Memorandum

Date: June 8th, 2018

Re: Level III Subdivision and Site Plan:
New 8-unit: 7 residential and 1 commercial condominium (3-stories)
28 Vannah Avenue

Project # PL000030-2018
Vannah White, LLC, Applicant

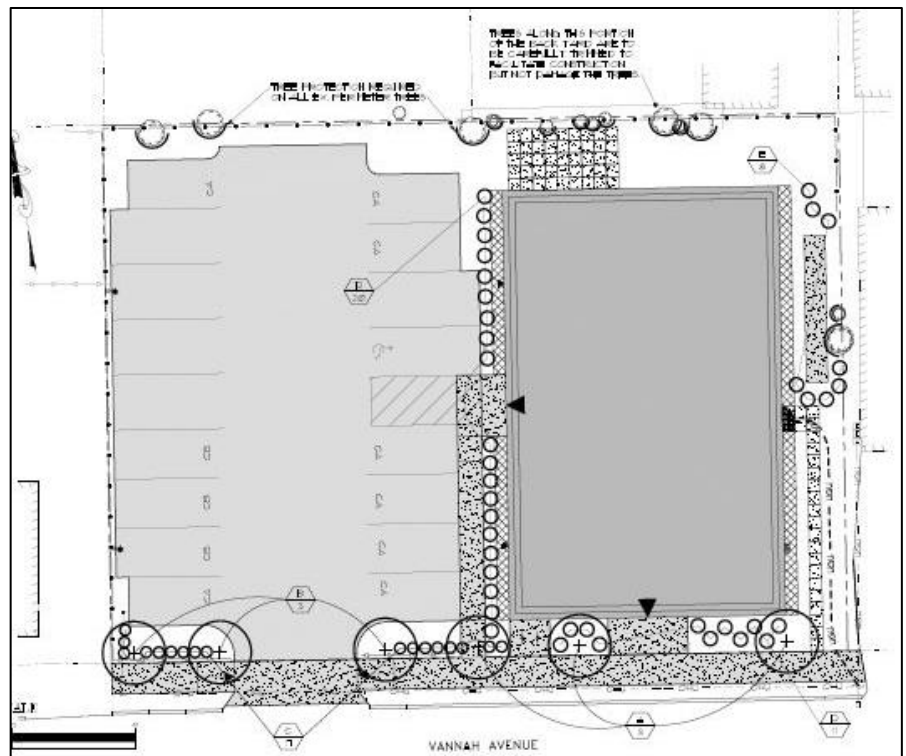
The proposal is for a new 3 story gabled building (with basement) on the site of the existing building, with the parking lot approximately as existing with existing trees preserved around the perimeter and a new sidewalk, street trees and landscaping along the frontage.

The proposal includes fencing around three sides of the project: the west and north sides (and small part of the east side at rear) are white PVC stockade style fencing; at the front along the back of the sidewalk (in front of the trees) is a black vertical metal decorative fence at 4 feet in height. Other site features include a communal patio at the rear and HVAC compressors along the east side.
